ADA ACTION PLAN

SEDGWICK COUNTY APPRAISERS OFFICE
434 N. MARKET, WICHITA, KS

Revised April 26, 2007

Southeast Entrance / Exit

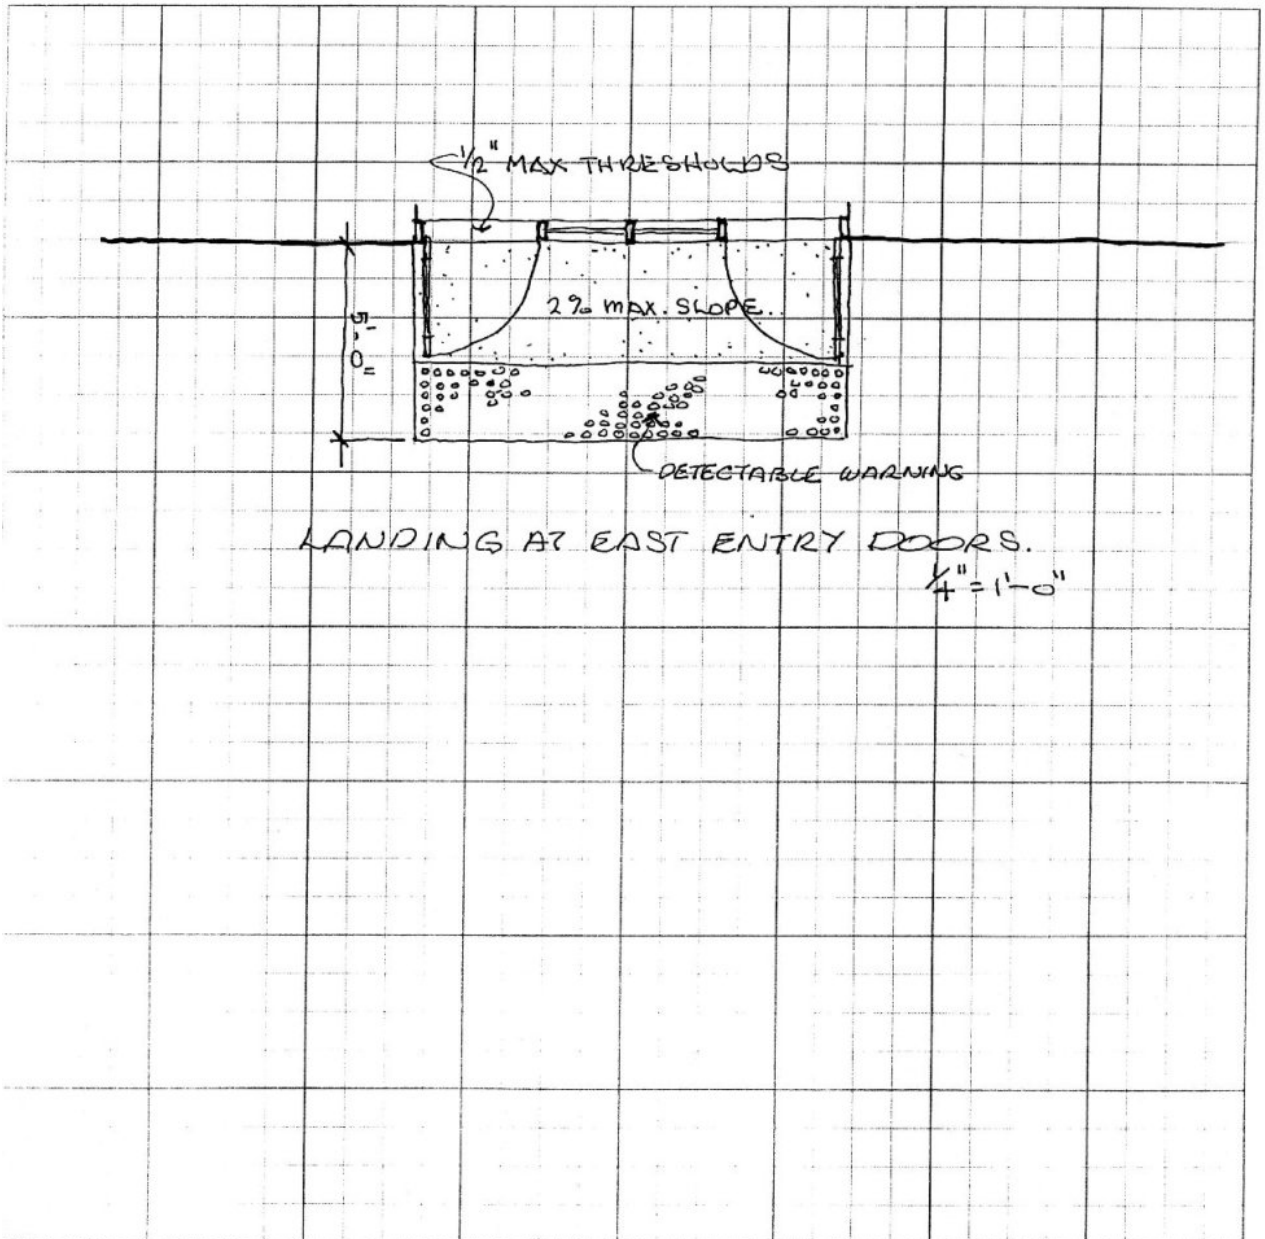
Replace area outlined above with concrete. Install truncated dome insert just outside public door as shown in photo above. Slope must be uniform, no greater than 2% and away from building.

Change in level at door threshold must total 1/2" or less.

Lobby

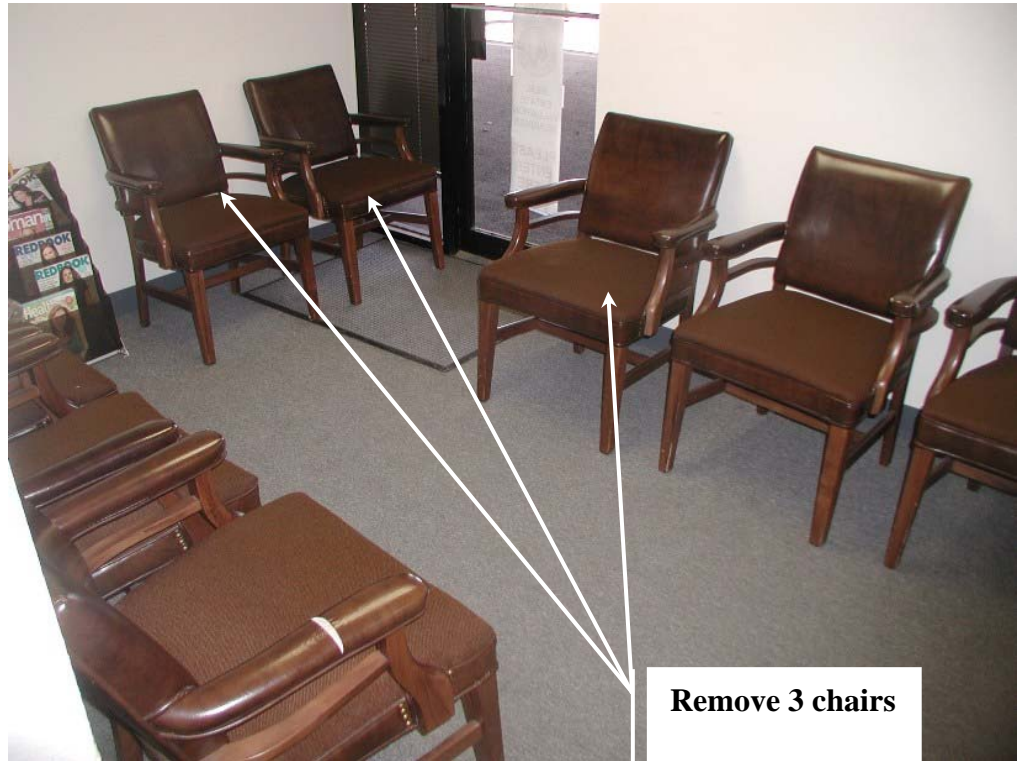
Removing 3 chairs will provide the required maneuvering space.

Krehbiel Architecture Public Restroom Sketch

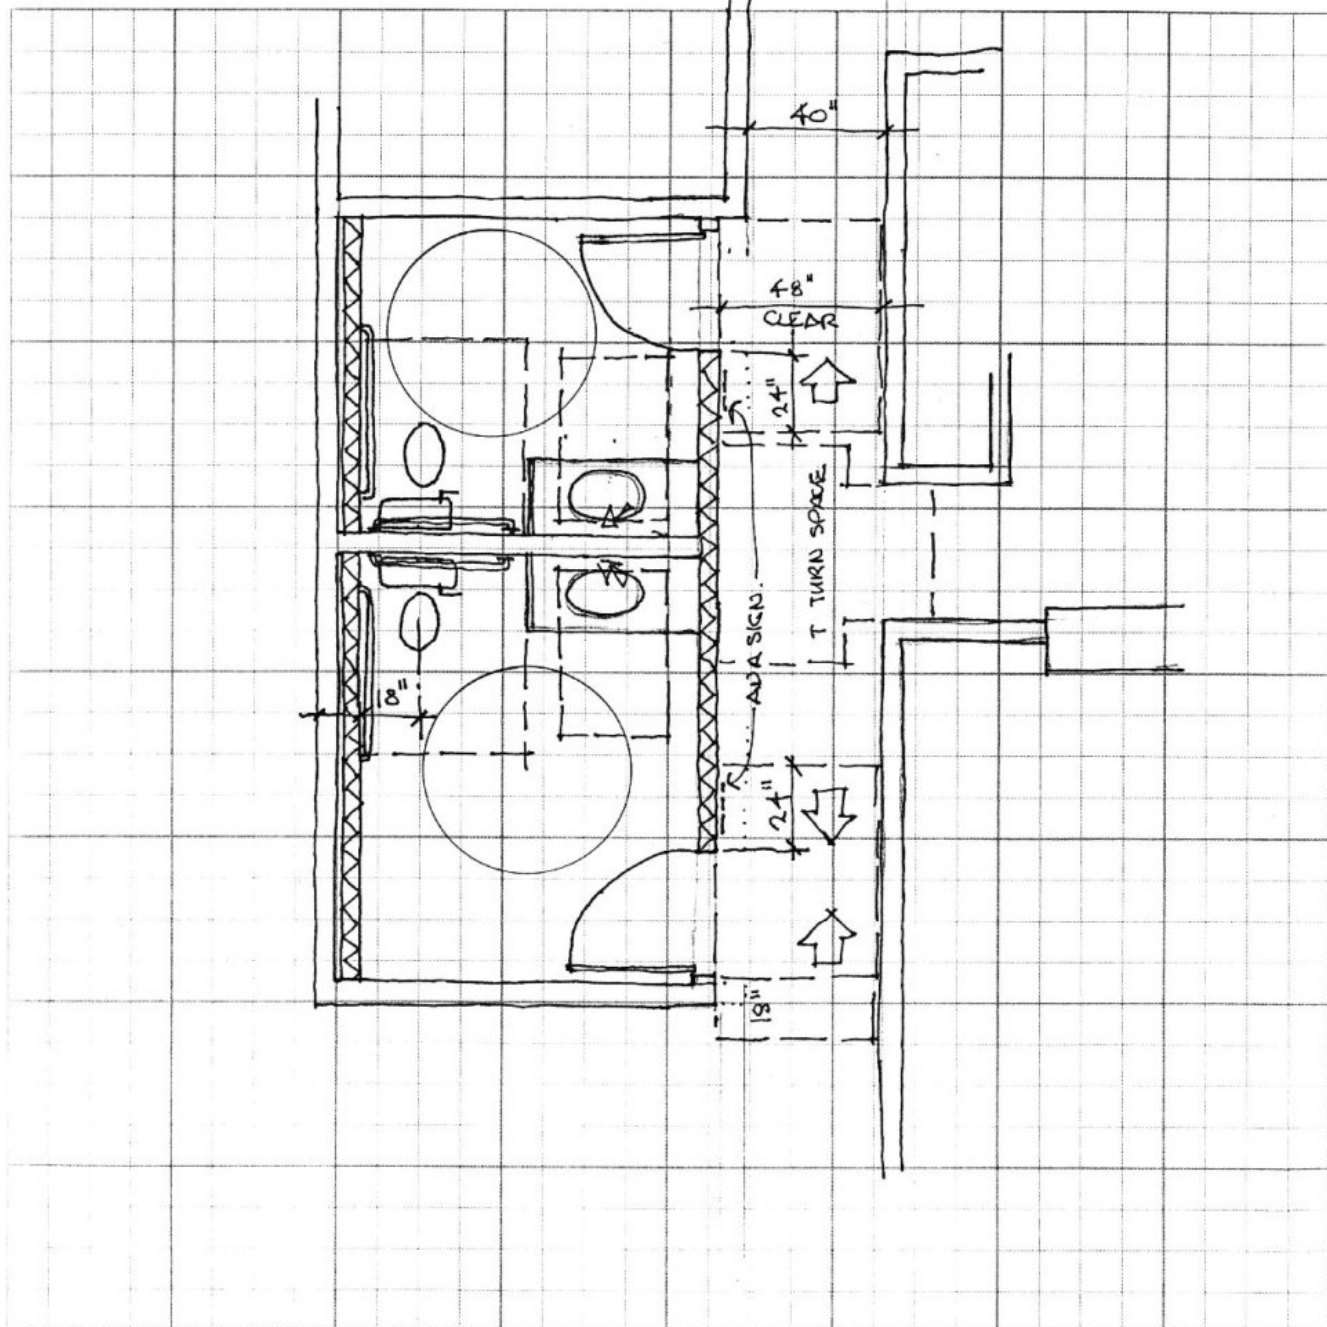
Hallway – maneuvering room adjacent to restrooms: Provide a 54" wide hallway. Relocate the south wall of the MRR, WRR and four feet of the break room wall to the north 14". See restroom Sketch.	Building Owner	January 2, 2008	Fig 404	Sketch 2
Hallway – maneuvering room adjacent to hearing rooms: Provide a minimum 42" wide hallway. Remove east hearing room door. Move systems furniture along the north side of hall a minimum of 2" north.	Appraiser's Office	July 5, 2007	Fig 404	
Replace all first floor round door knobs with lever type handles that do not require a tight grasp.	Building Owner	July 5, 2007	309	
Hearing room: Designate the cubicle directly inside the east hallway door as accessible and install ADA compliant sign on cubicle wall.	Appraiser's Office	July 5, 2007	Signs	
Appropriate maneuvering space does not exist inside the southwest entrance doors. Remove large wood table and boxes from southwest entrance.	Appraiser's Office	July 5, 2007	Fig 404
